# NFPA 72<sup>®</sup> *National Fire Alarm and Signaling Code*

## 2016 Changes

November 18, 2015 | Richard Roux

FIGURE 17.7.5.6.5.1(A) Detector Location Requirements for Wall Sections.

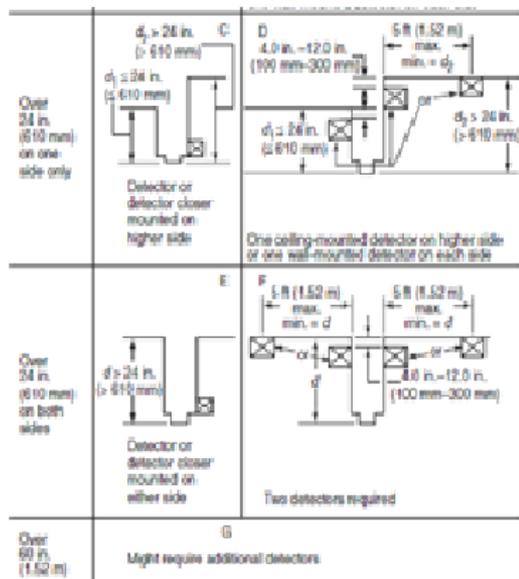
- Revised several of the requirements for placement of smoke detectors used for door release to provide additional flexibility in locating detectors; revised Figure 17.7.5.6.5.1(A) to delete the minimum 4 in. (100 mm) requirement for placement of detectors on sidewalls
- (Continued on next slide)

FIGURE 17.7.5.6.5.3(B) Detector(s) Location  $\pm 24$  in. (0.6 m) Requirements for Group Doorways.

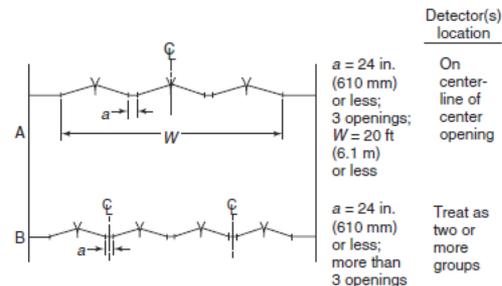
- Revised Figure 17.7.5.6.5.3(B) and Figure 17.7.5.6.5.3(C) to specify a  $\pm 24$  in. (0.6 m) tolerance for smoke detectors located at group doorways when using smoke detectors for the purpose of door release

### 23.6.1\* SLC Zones.

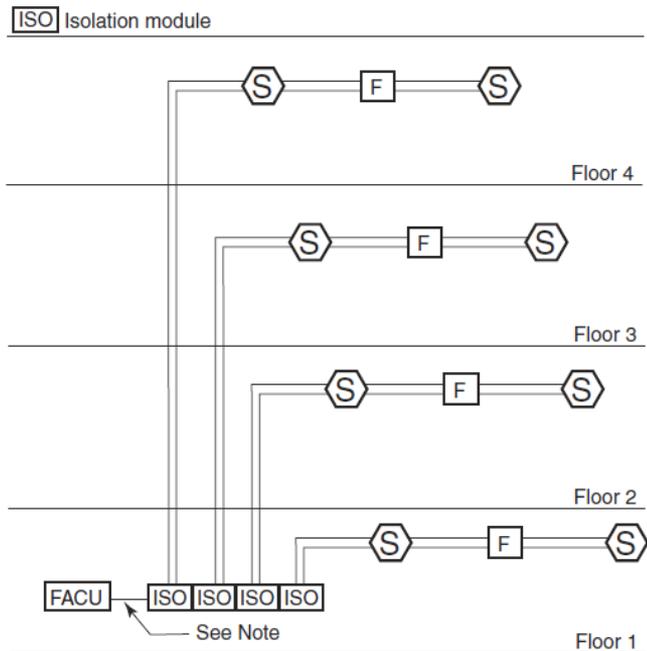
- Added 23.6.1, introducing the concept of signaling line circuit (SLC) zones and the requirements associated with not permitting a single fault on the SLC to cause the loss of devices in more than one zone

A single fault on a pathway connected to the addressable devices shall not cause the loss of the devices in more than ~~50 addressable devices~~ one zone.

FIGURE A.23.6.1(b) Class A Isolation Method.

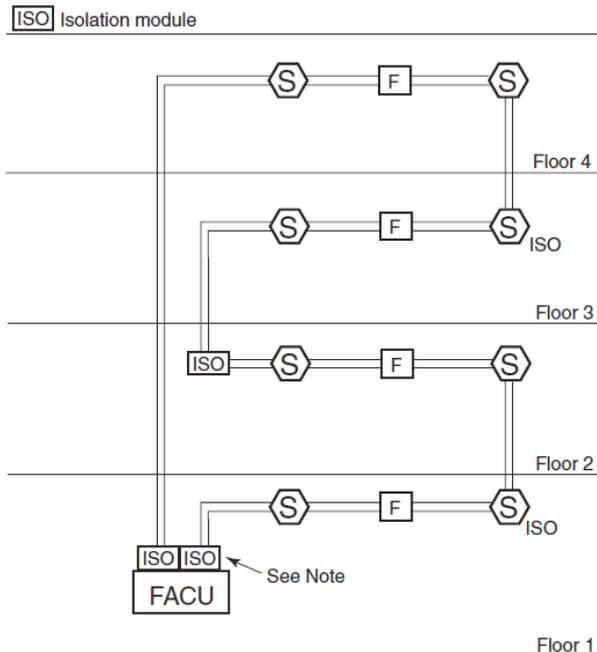
Note: The two isolation modules shown at the FACP are not required if the panel SLC controller is internally isolated from shorts between outgoing and return termination points.
